MOORE PUBLIC SCHOOLS -
OLD SCHOOL REPLACEMENT
Moore Public Schools - Moore, Oklahoma
AGP - Moore, Oklahoma

ADDENDUM NO. 2
April 14, 2026

A102

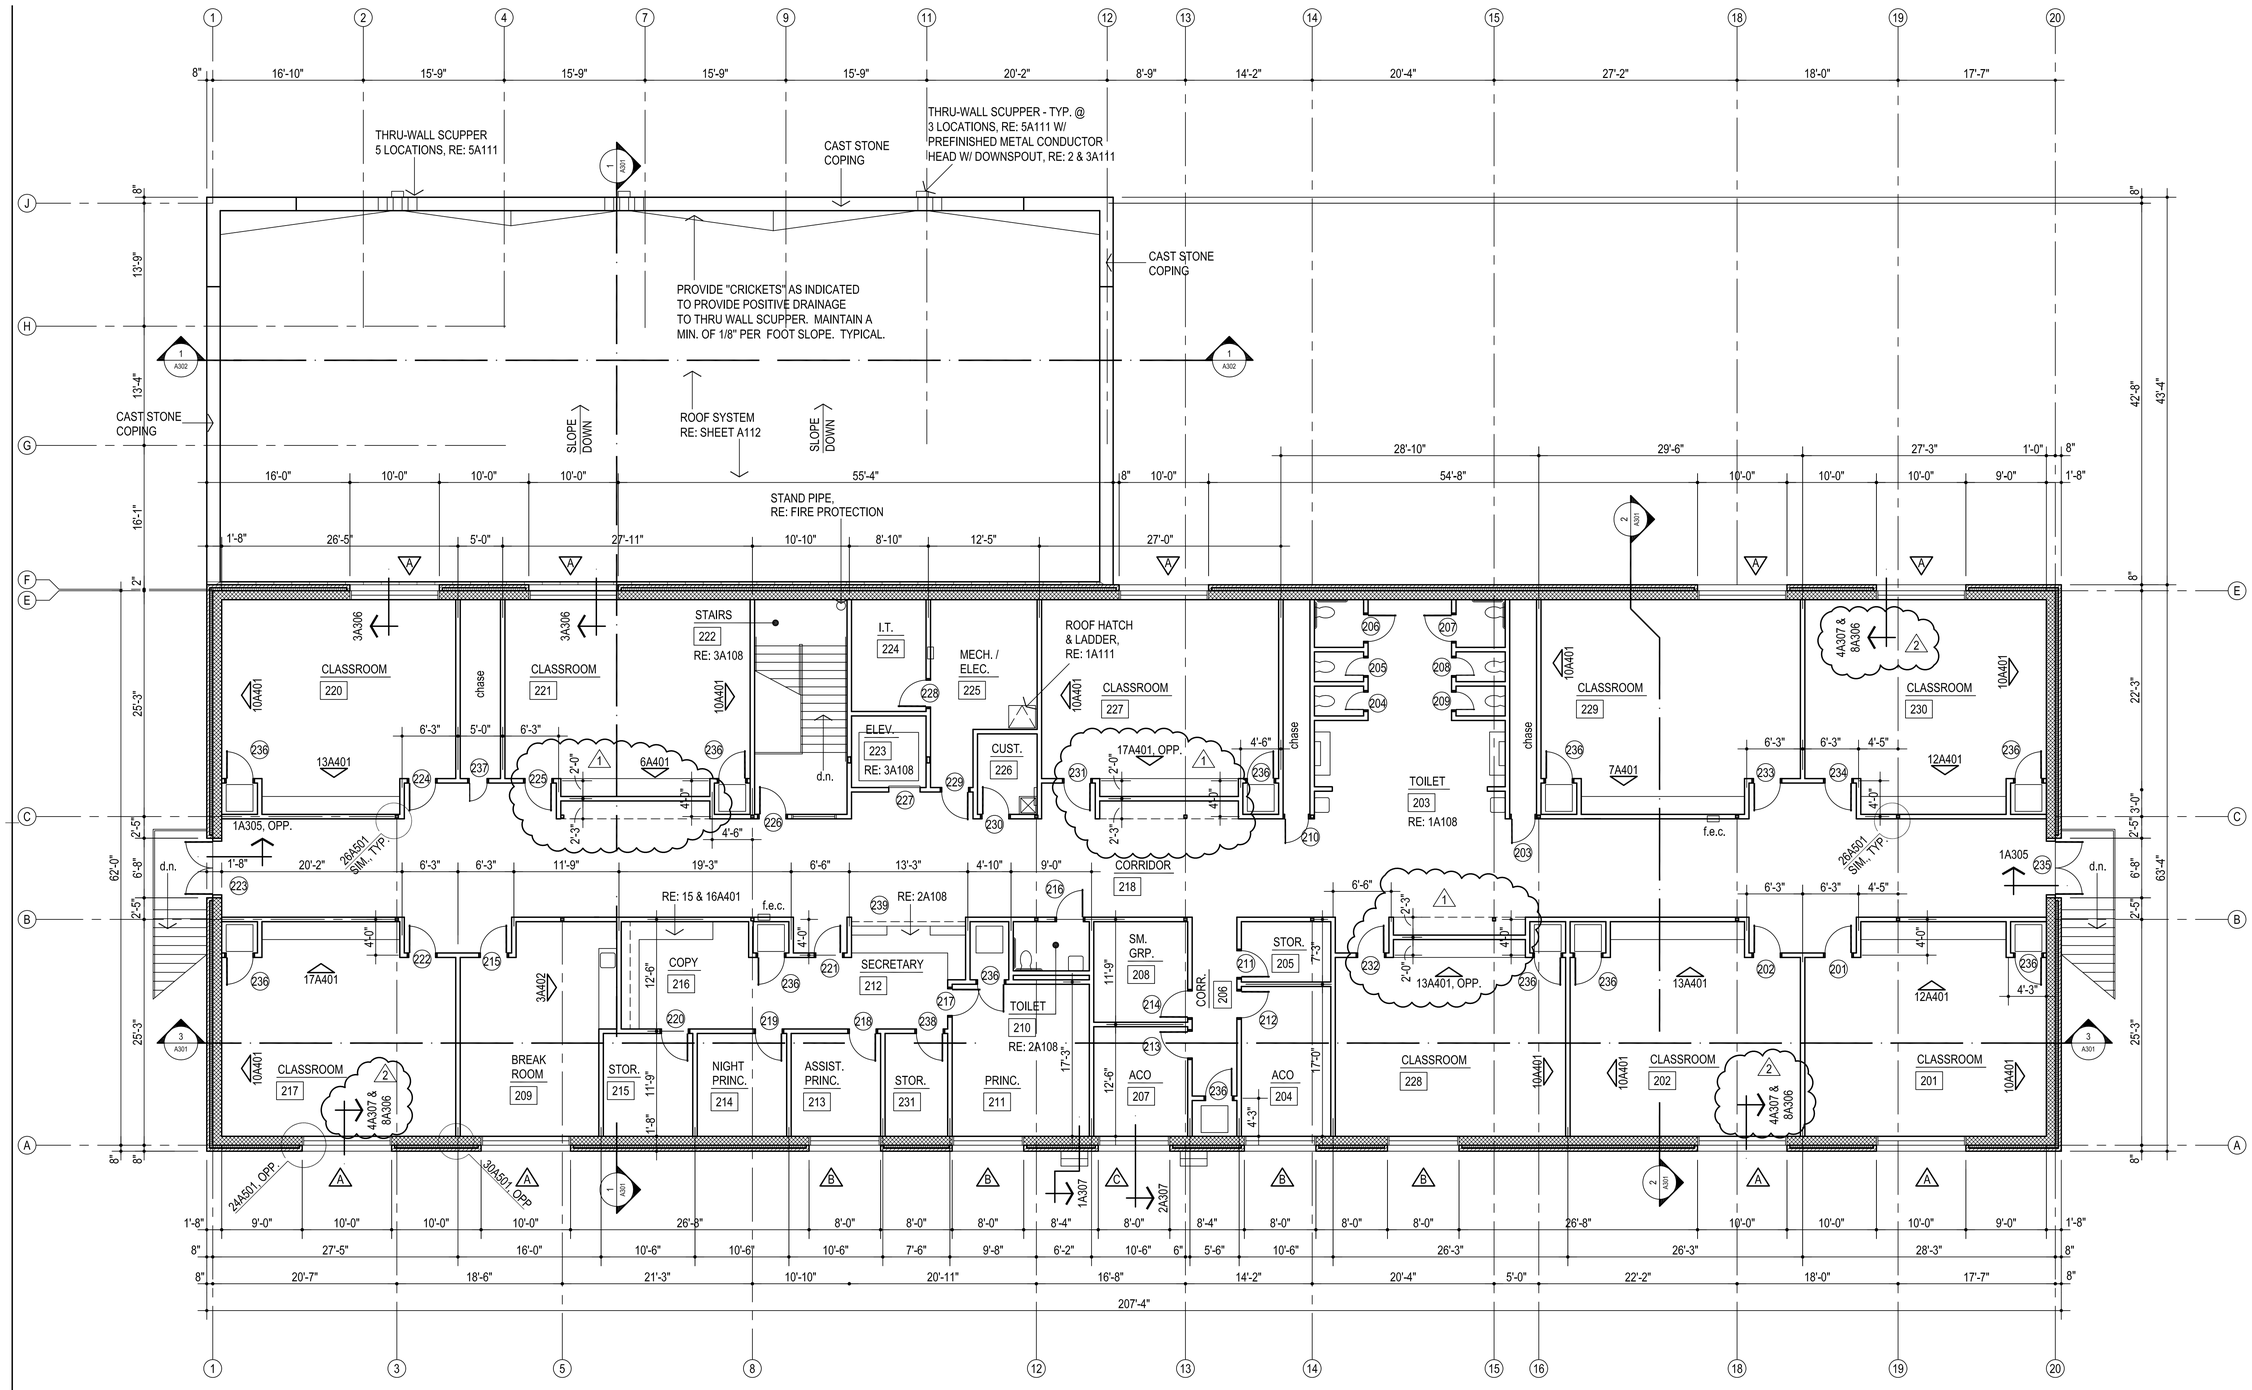
2. Sheet A102, Detail #1, First Floor Plan and Sheet A103, Detail #1, Second Floor Plan: revised / added references at windows as indicated. Refer to attached revised drawings.

A104

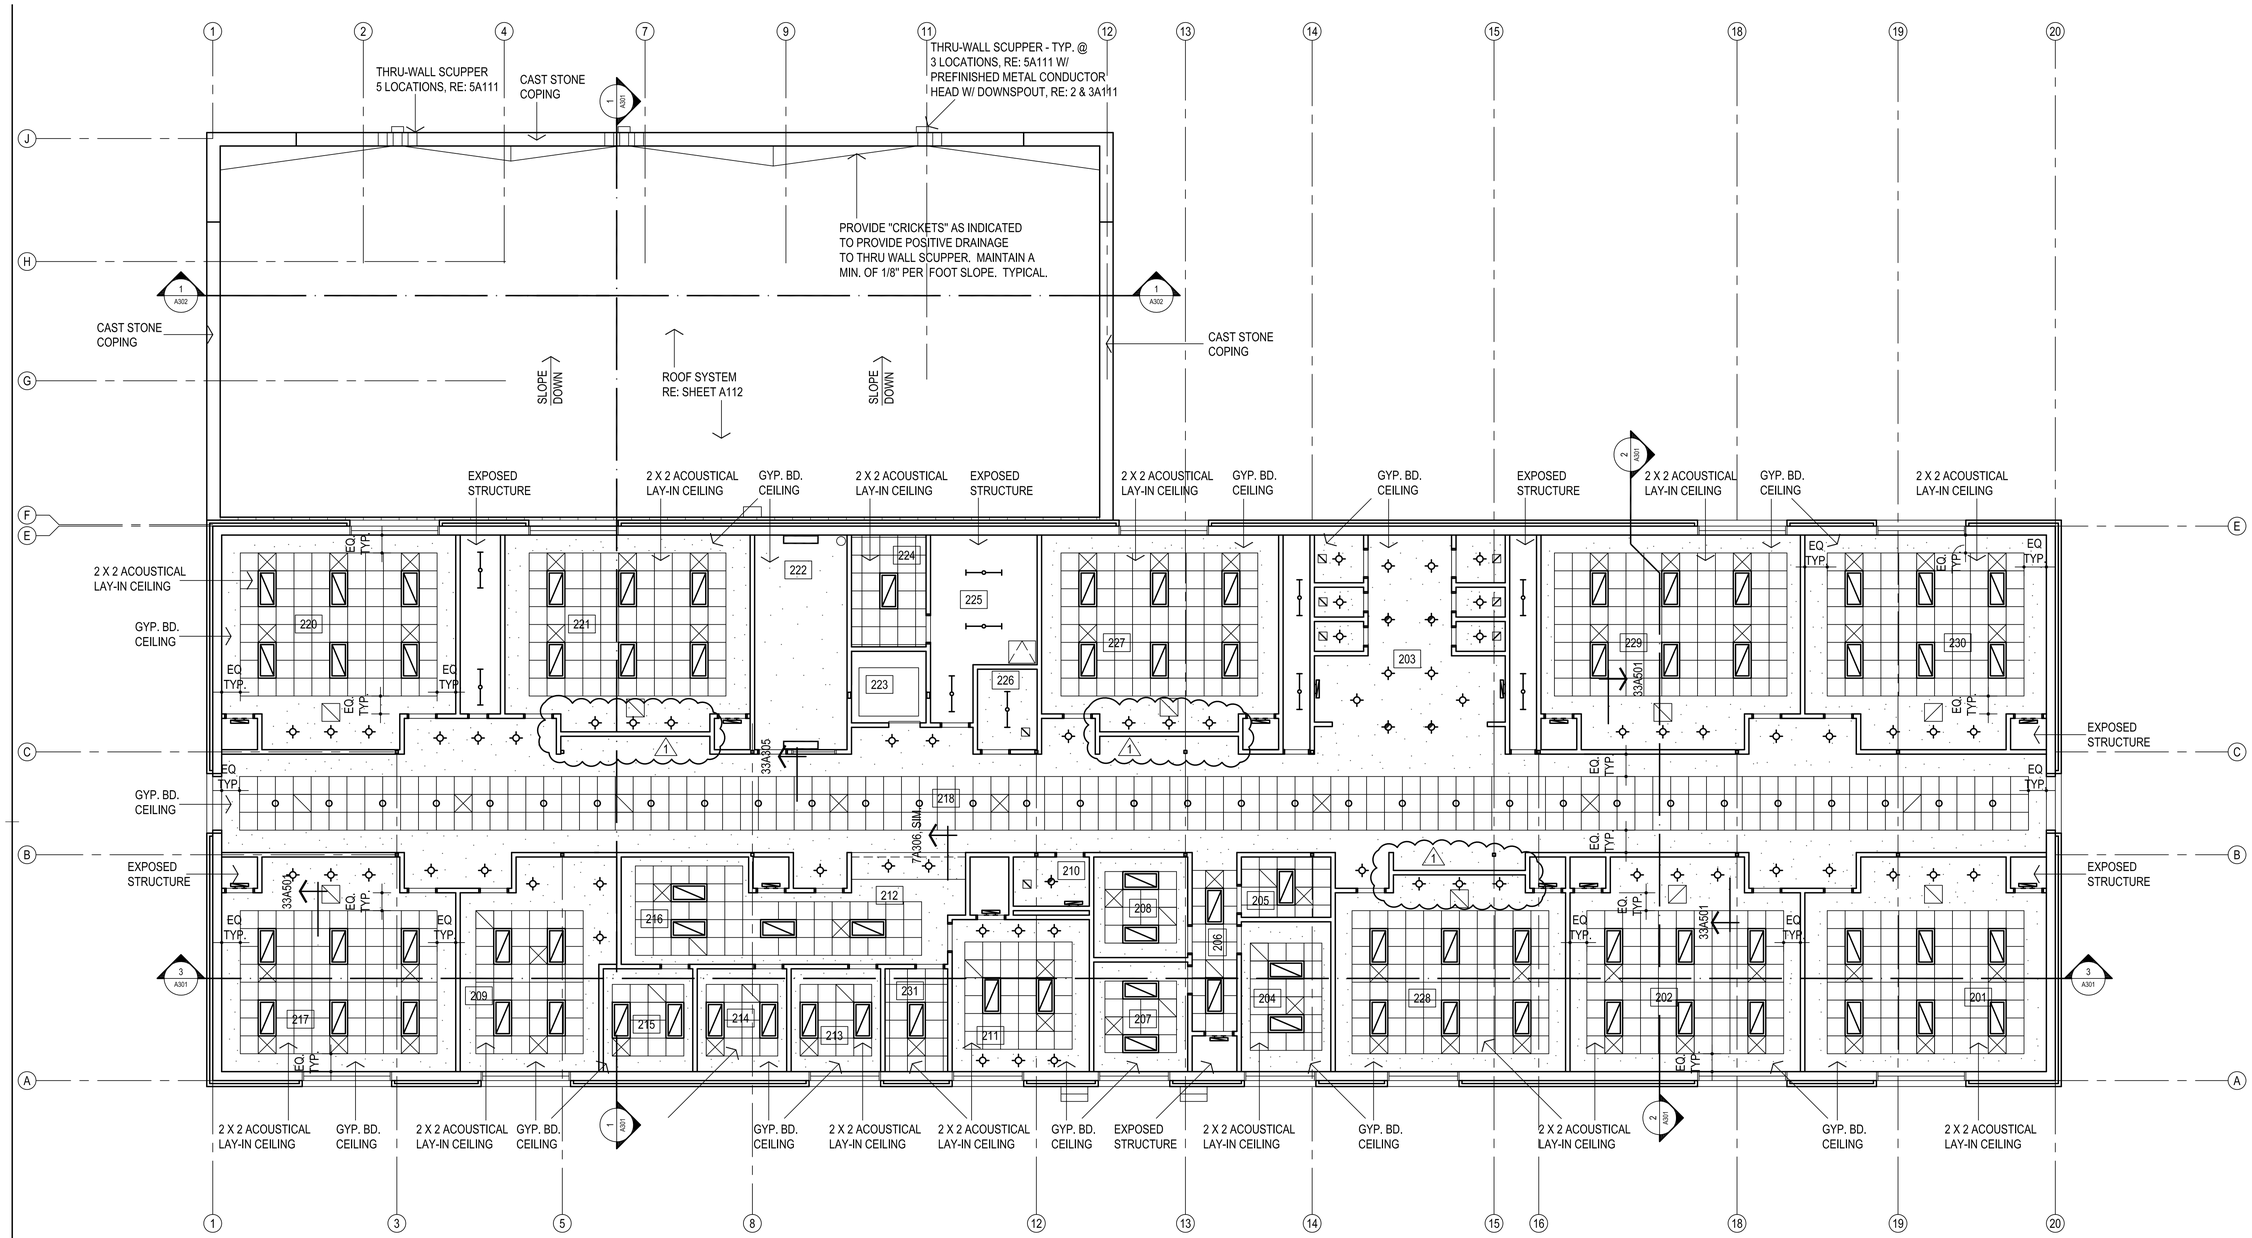
3. Sheet A104, Detail #1, Reflected Ceiling Plan – First Floor and Sheet A105, Detail #1, Reflected Ceiling Plan – Second Floor: revise ceilings

as required to meet revised grille / louver locations as per revised mechanical drawings. Refer to attached revised drawings.

A107

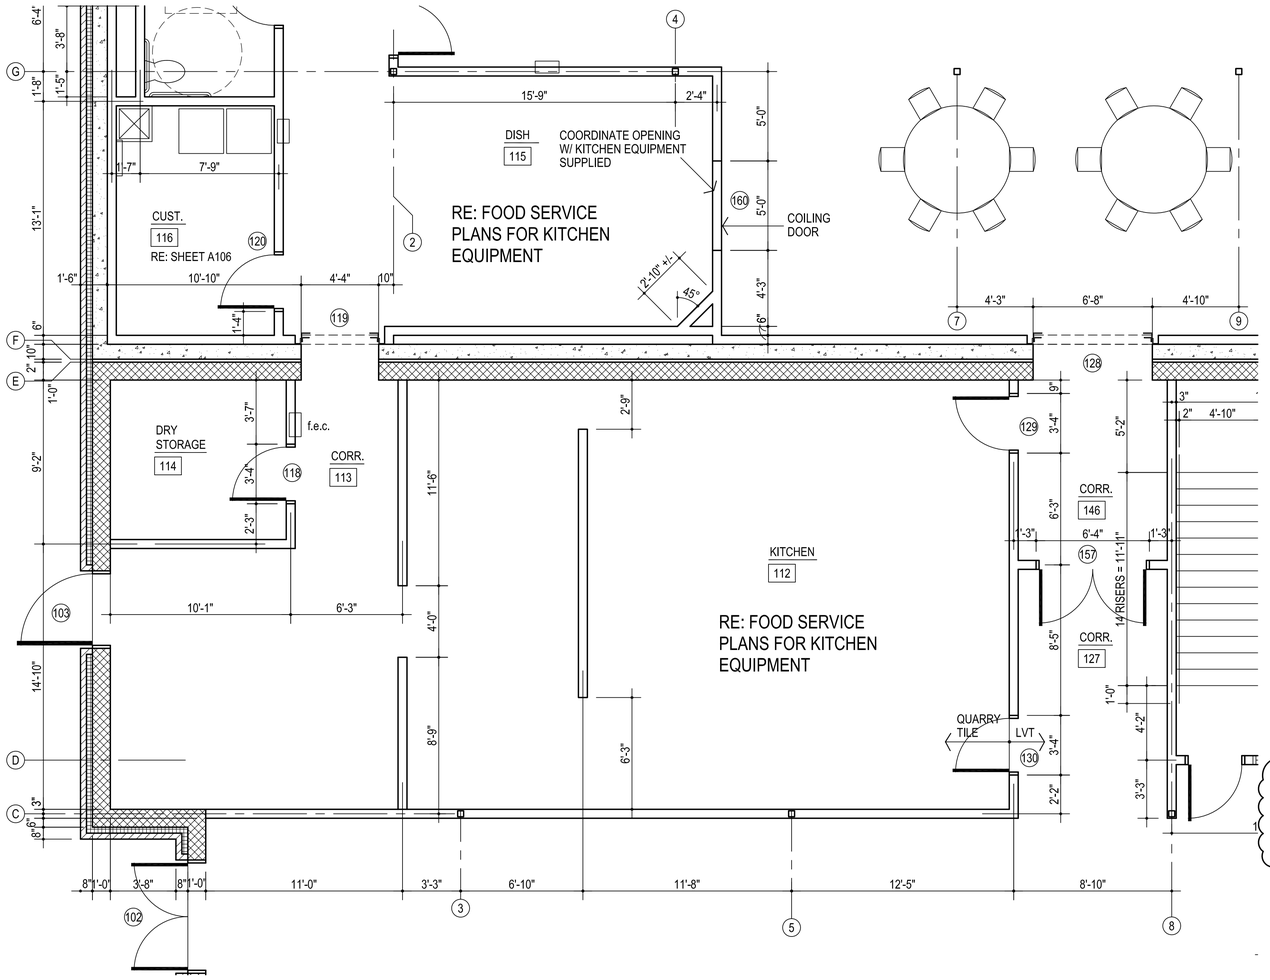
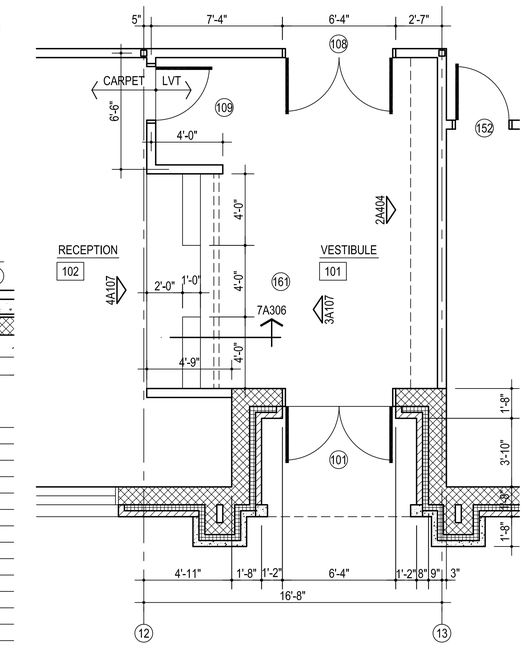
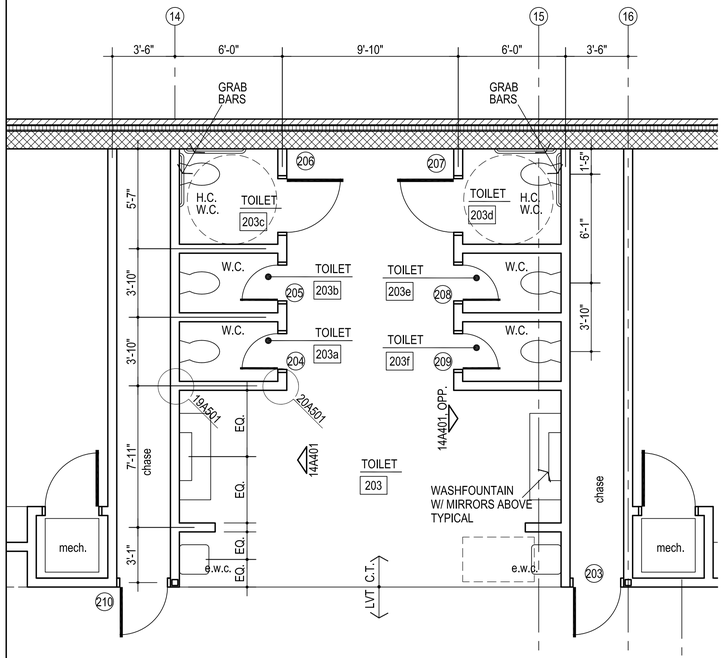
4. Sheet A107, Details #3 & 4, Interior Elevations - Rooms #101 & 102: revise dimensions as noted to allow for changes to ceiling heights. Refer to attached revised drawings.

A108

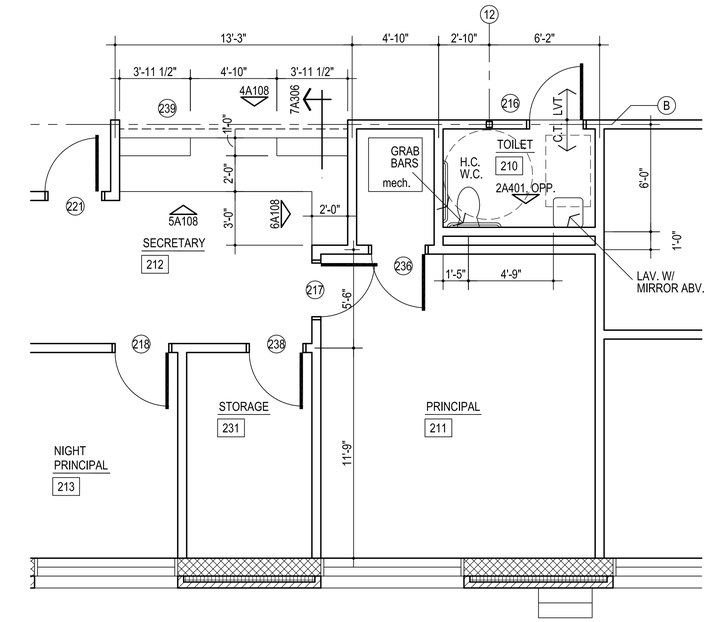
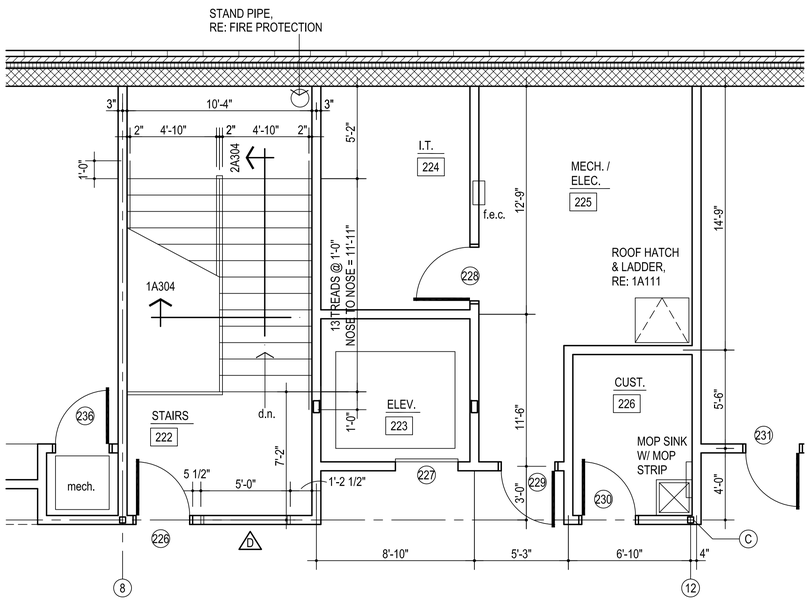
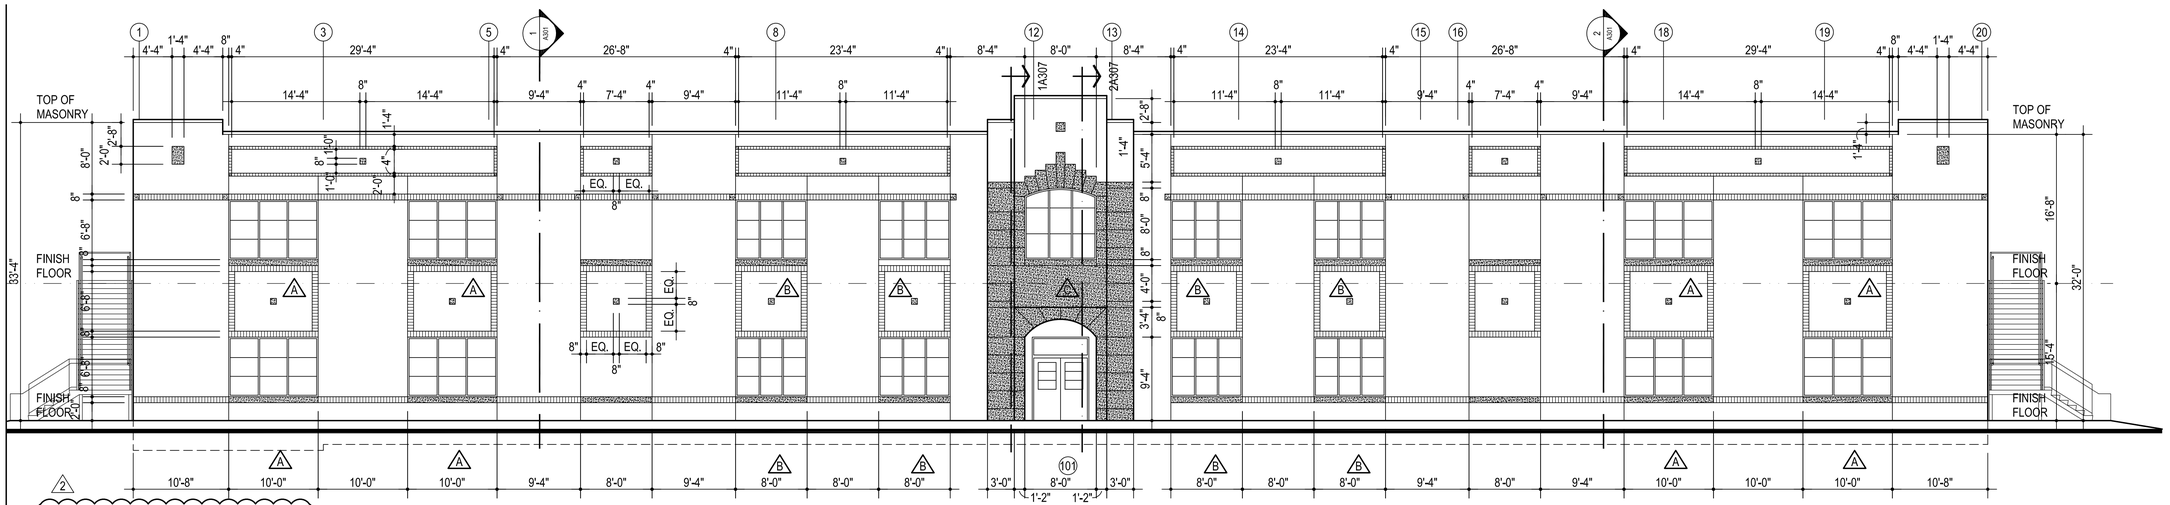
5. Sheet A108, Details #5 & 6, Interior Elevations - Room #212: revise dimensions as noted to allow for changes to ceiling heights. Refer to attached revised drawing.
